**Subject: Bid Package #2**  
Abbott Middle School HVAC Replcmt-DSA 01-119556  
George Hall Elementary School HVAC Replcmt-DSA 01 119523  
Laurel Elementary School HVAC Replcmt DSA 01-119551  
**San Mateo - Foster City School District**

**ADDENDUM NO. 1**

**Subject:** Abbott Middle School HVAC Replacement  
San Mateo - Foster City School District  
Aedis Project No. 2021005.06  
DSA Application #01-119556

### ADDENDUM NO. 1

GEORGE HALL ELEMENTARY SCHOOL - HVAC REPLACEMENT SAN MATEO-FOSTER CITY SCHOOL DISTRICT	
		FILE NO.: 41-26	SHEET
387 S. 1st Street, Suite 300 San Jose, CA., 95113		tel: (408) 300 - 5160 fax: (408) 300 - 5121	APPL NO.: 01-119523 JOB NO.: 2021005.02 DATE: 11/24/2021
			<b>AD1-A9.10A</b>

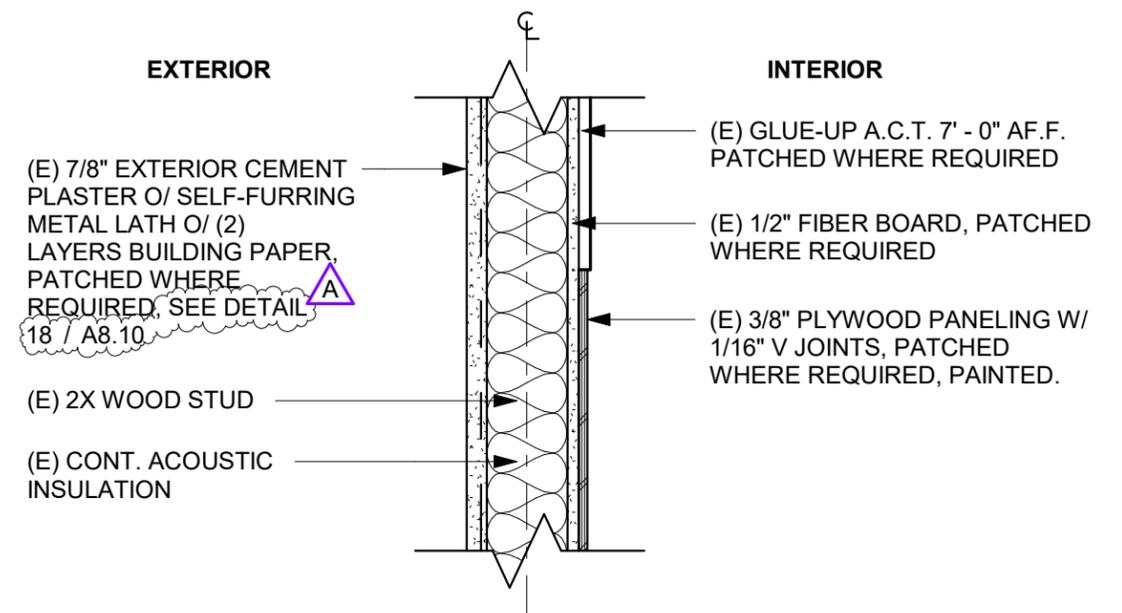
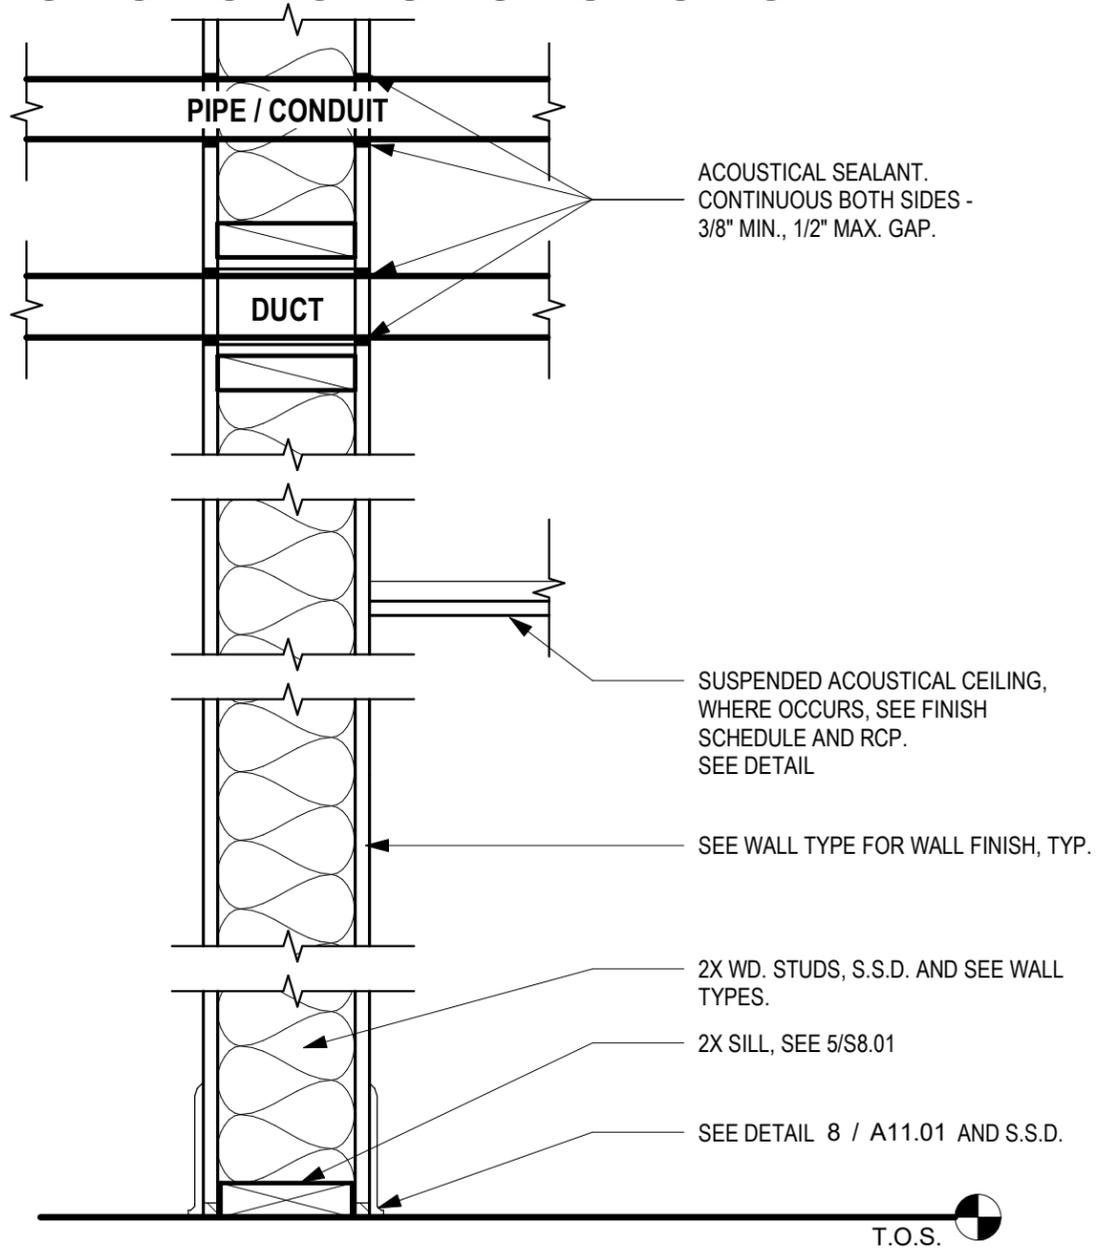
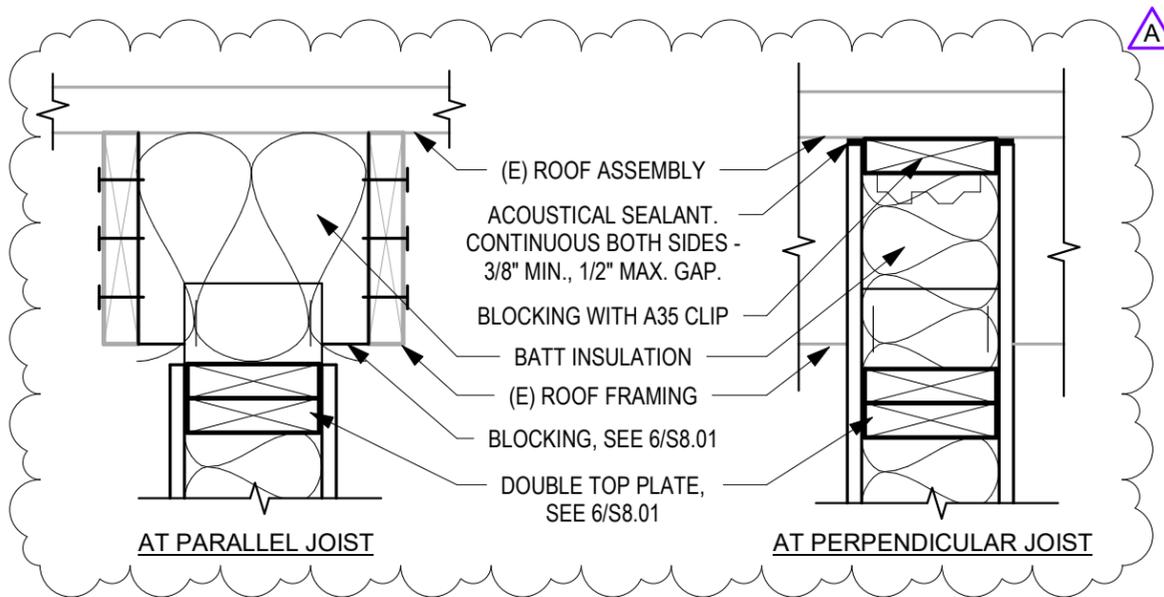
ITEM NO. 1.11: DRAWING SHEET A9.10 – INTERIOR DETAILS, WALL TYPES, AND INTERIOR ELEVATIONS

- Revise: Details 1 & 5 per AD1-A9.10a
- Revise: Detail 6 per AD1-A9.10b
- Revise: At Detail 8/A9.10 revise “1"x2"x2.5" GA” to “1"x2"x25 GA”

# NEW SHEET NOTES  
 38. INSTALL EXHAUST FAN ON ROOF.

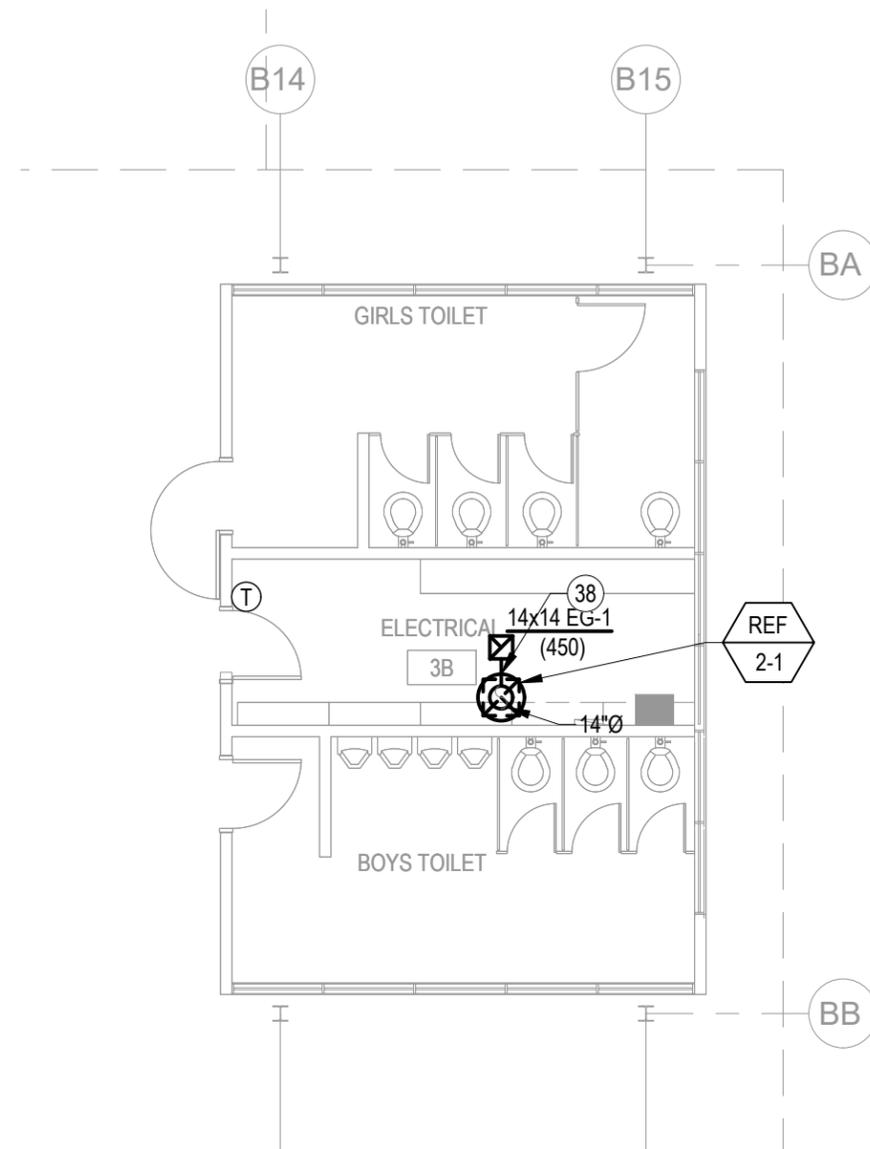
ITEM NO. 1.15: DRAWING SHEET MP2.04 – FLOOR PLAN – NEW – ESCALON BLDG – MECHANICAL & PLUMBING

- Revise: Location of HP-32 per AD1-MP2.04a
- Revise: General Notes #4 & #5 per AD1-MP2.04a
- Add: Dimension per AD1-MP2.04a
- Add: View 5/AD1-MP2.04 Partial Floor Plan - Wing 2 - New – Mechanical & Plumbing per AD1-MP2.04b
- Add: New Sheet Note #38 per AD1-MP2.04b
- Add: Exhaust Fan per AD1-MP2.04c

16 EXHAUST FAN MOUNTING

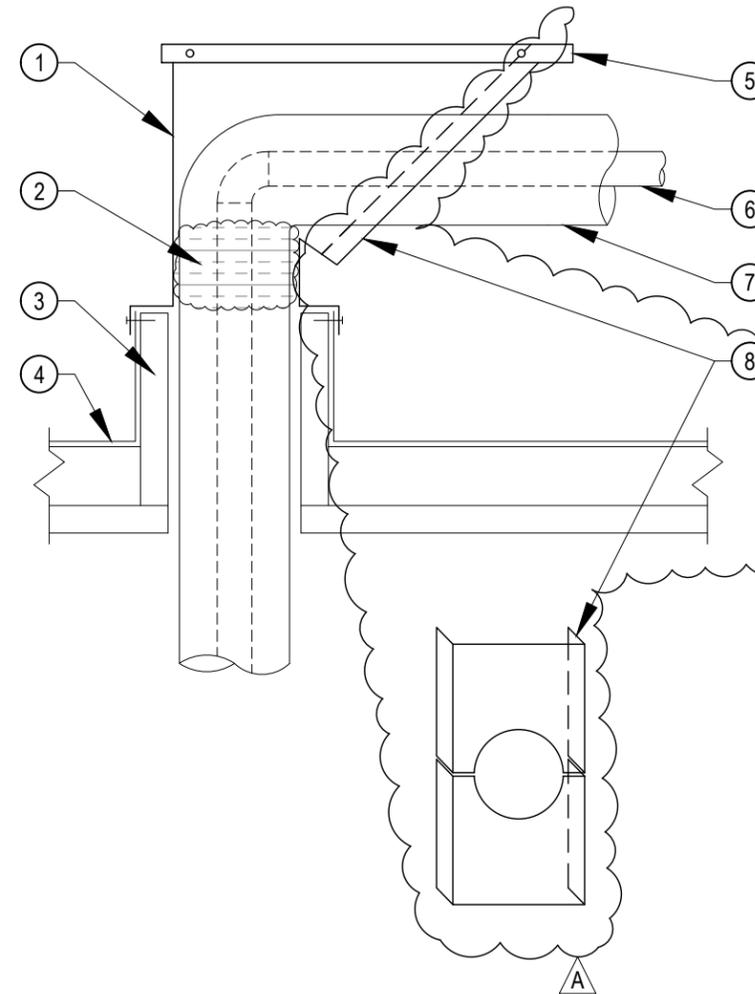
ITEM NO. 1.1: DRAWING SHEET MP6.01 – DETAILS – MECHANICAL & PLUMBING

- Revise: Detail 4 per AD1-MP6.01
- Add: Detail 16 per AD1-MP6.01

DATE **11/24/2021**  
JOB # **2021005.02**  
SHEET # **AD-1  
E2.2**

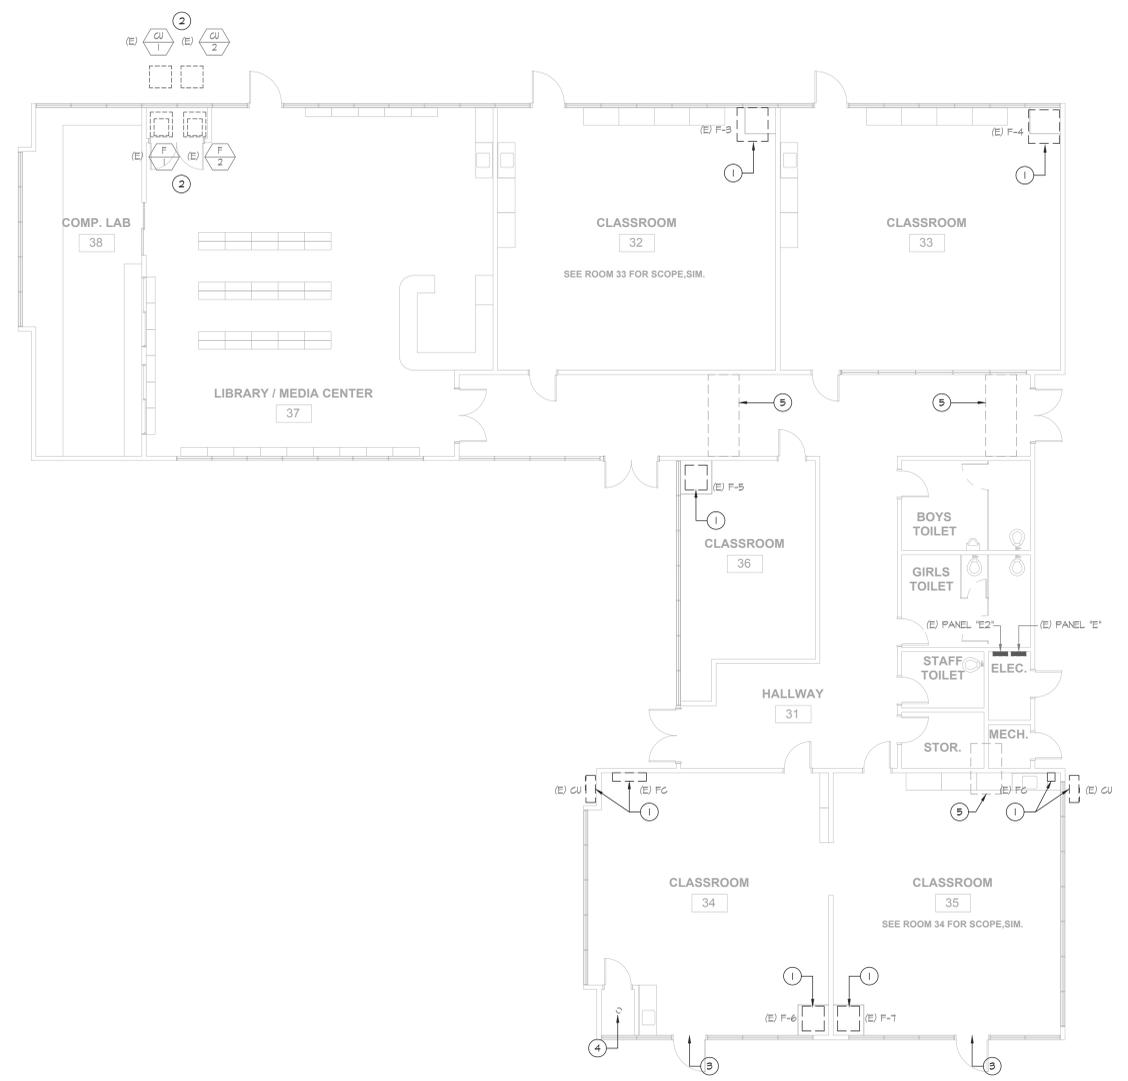
ITEM NO. 1.18: DRAWING SHEET E2.2 – ELECTRICAL DEMO FLOOR PLANS, ESCALON

Revise: Demolition Sheet Note #4 per AD1-E2.2

**E3.1**

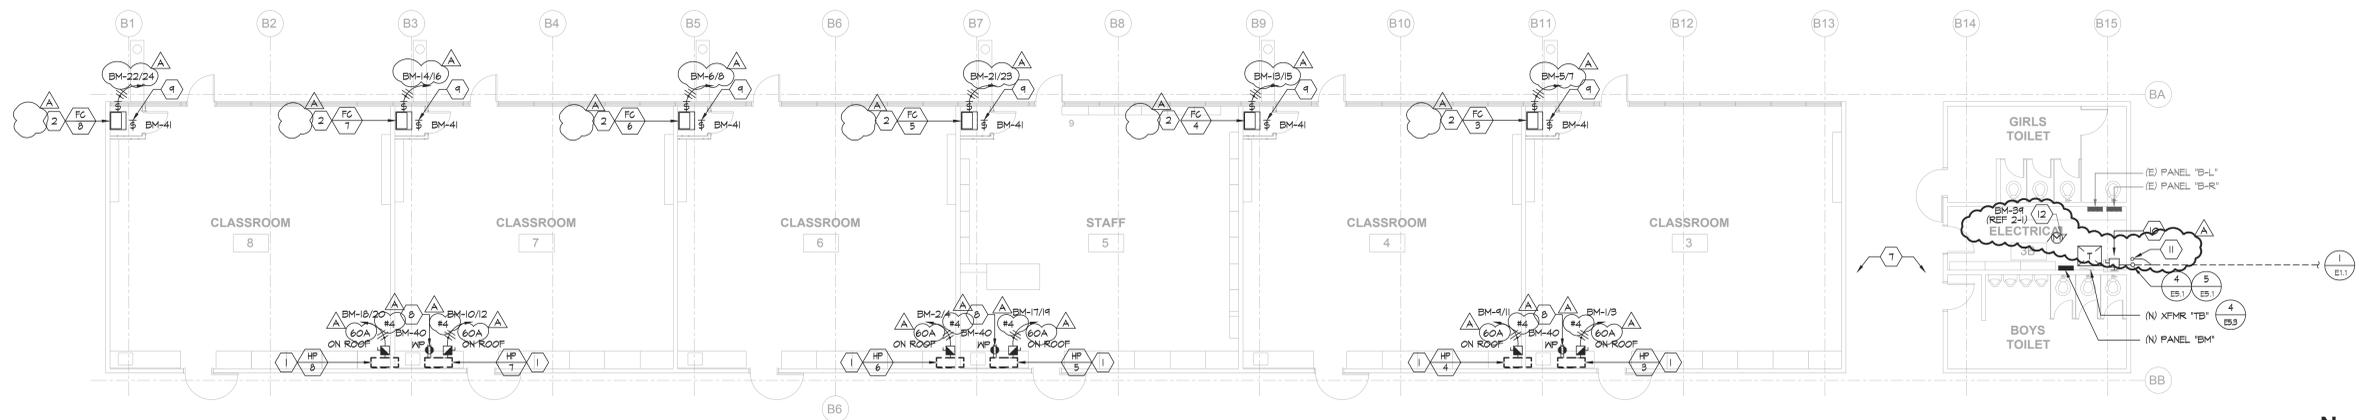
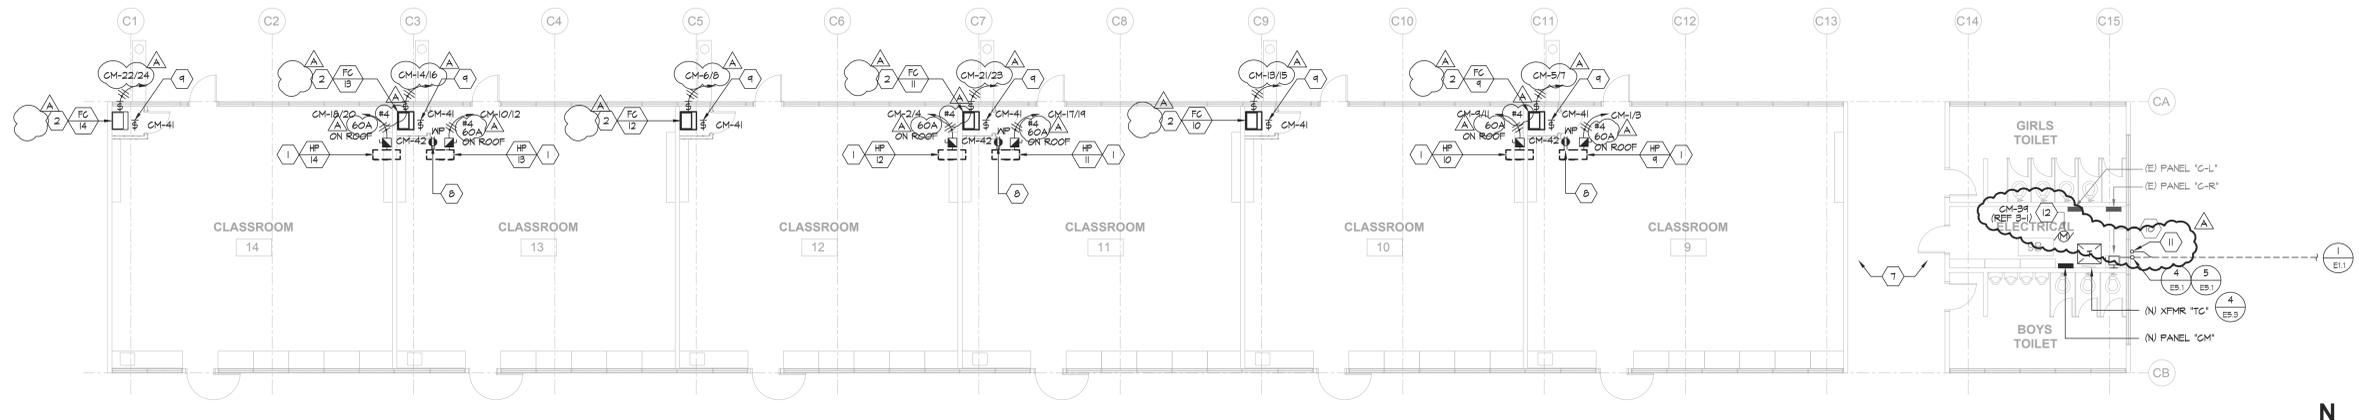
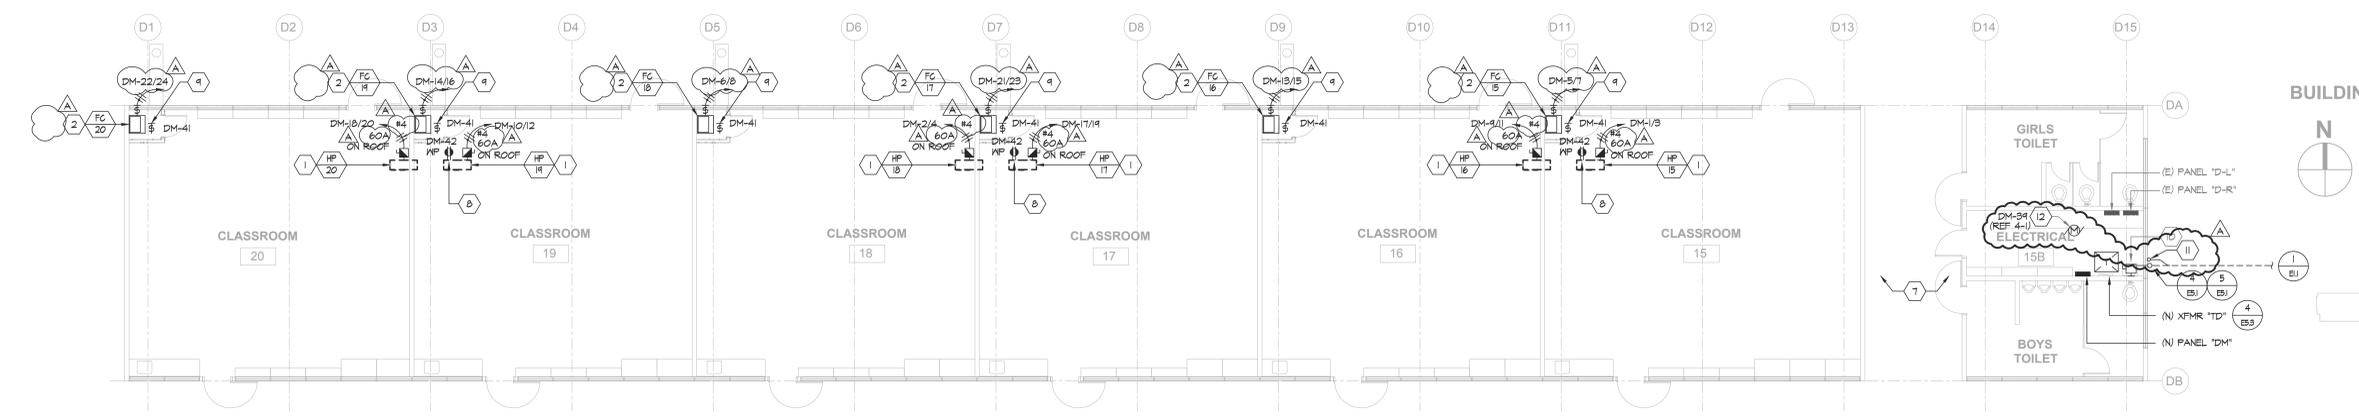
ITEM NO. 1.19: DRAWING SHEET E3.1 – ELECTRICAL NEW FLOOR PLANS, WINGS #1, 2, 3 & 4

Revise: Electrical plans 1/E3.1, 2/E3.1, 3/E3.1 & 4/E3.1 per AD1-E3.1

Add: General Note #6 per AD1-E3.1

Revise: Sheet Note #6 per AD1-E3.1

Add: Sheet Notes #11 & #12 per AD1-E3.1

Add: Solar Conduit stub ups at each wing per AD1-E3.1

Add: Power for exhaust fan per AD1-E3.1
